Form 3160-5 (August 2007)

UNITED STATES DEPARTMENT OF THE INTERIOR

Cotton Draw Unit 237H - New Wellhead procedure details

CDU 237H– APD DRILLING PLAN JSP 12.11.13

CONTINGENCY MODE

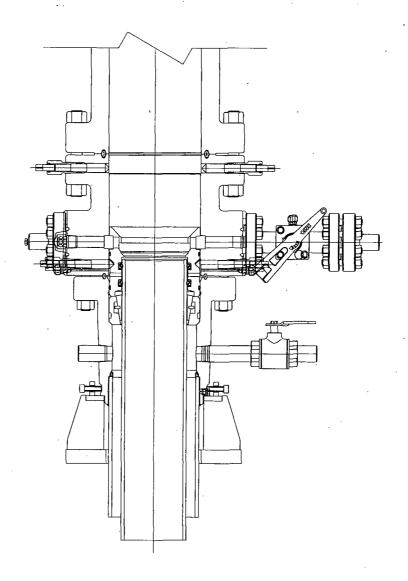
13. Describe Proposed or Completed Operation (clearly state all pertinent details, including estimated starting date of any proposed work and approximate duration thereof. If the proposal is to deepen directionally or recomplete horizontally, give subsurface locations and measured and true vertical depths of all pertinent markers and zones. Attach the Bond under which the work will be performed or provide the Bond No. on file with BLM/BIA. Required subsequent reports shall be filed within 30 days following completion of the involved operations. If the operation results in a multiple completion or recompletion in a new interval, a Form 3160-4 shall be filed once testing has been completed. Final Abandonment Notices shall be filed only after all requirements, including reclamation, have been completed, and the operator has determined that the site is ready for final inspection.) Devon Energy Production Company, L.P. respectfully proposes using a multi-bowl wellhead assembly (FMC Uni-head). This assembly will only be tested when installed on the surface casing. Minimum

working pressure of the blowout preventer (BOP) and related equipment (BOPE) required for drilling below the surface casing shoe shall be 3000 (3M) psi.						
Devon Energy would also like to request changing the 9-5/8" 40# J55 LTC intermediate casing to a mixed string consisting of 3400' of 36# J55 LTC and the remaining 1200' of 40# J55 LTC casing. The new safety factors are included in the attachments.						
(FMC Uni-head). This assembly will only be tested when installed on the surface casing. Minimum working pressure of the blowout preventer (BOP) and related equipment (BOPE) required for drilling below the surface casing shoe shall be 3000 (3M) psi. Devon Energy would also like to request changing the 9-5/8" 40# J55 LTC intermediate casing to a mixed string consisting of 3400' of 36# J55 LTC and the remaining 1200' of 40# J55 LTC casing. The new safety factors are included in the attachments. Please see the following attachments: * Revised Drilling Plan * FMC Unihead Schematics

- 3. Operator has proposed a multi-bowl wellhead assembly. This assembly will only be tested when installed on the surface casing. Minimum working pressure of the blowout preventer (BOP) and related equipment (BOPE) required for drilling below the surface casing shoe shall be 3000 (3M) psi.

PRIMARY MODE

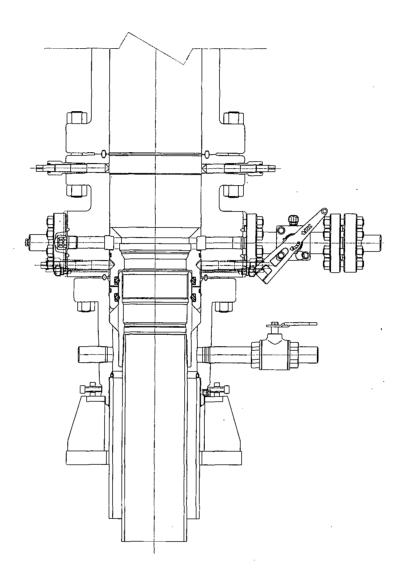
After running the 9-5/8' intermediate casing with a mandrel hanger, the 13-5/8" BOP/BOPE system with a minimum rating of 5M will already be installed on the FMC Uni-head. Please find attached the wellhead schematic.

- a. Wellhead shall be installed by manufacturer's representatives, submit documentation with subsequent sundry.
 - b. If the welding is performed by a third party, the manufacturer's representative shall monitor the temperature to verify that it does not exceed the maximum temperature of the seal.

- c. Manufacturer representative shall install the test plug for the initial BOP test.
 - d. Operator shall perform the intermediate casing integrity test to 70% of the casing burst. This will test the multi-bowl seals.

- e. If the cement does not circulate and one inch operations would have been possible with a standard wellhead, the well head shall be cut off, cementing operations performed and another wellhead installed.
